Town Council

CONDITIONAL ZONING – ASPEN CHAPEL HILL

10.19.2022

SITE PLAN

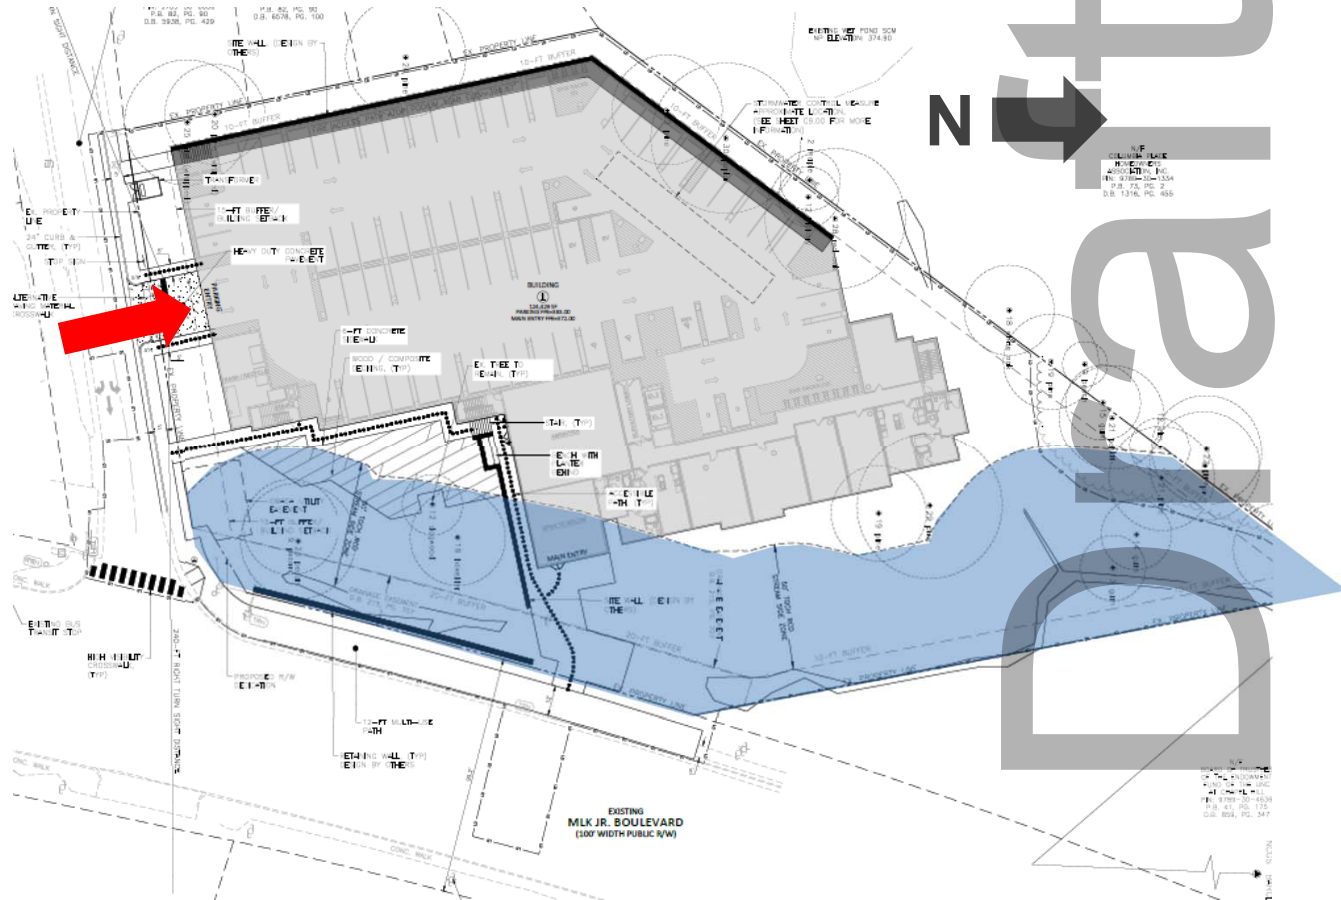
Board/ Commission	Recommendations
CDC	<ul style="list-style-type: none">• No RCD encroachment, make the RCD an amenity
TCAB	<ul style="list-style-type: none">• Additional secure bike parking• Maximize bike parking elevators• EV parking for 5% of spaces, infrastructure for future increase• Survey of tenant transportation needs• Designate moped parking areas• Consider a passenger drop-off zone on Longview St• Supportive of proposed vehicular parking reduction
HAB	<ul style="list-style-type: none">• Approve as proposed

Board/ Commission	Recommendations
ESAB	<ul style="list-style-type: none">• Bike parking for at least 20% of residents• All-electric appliances and high-efficiency HVAC• Consider stormwater design to accommodate 50- and 100-year events
Planning Commission	<ul style="list-style-type: none">• Scooter parking and additional bike parking• Minimize RCD encroachment, restore stream and make an amenity• Affordable units should be equally appealing – consider design and location
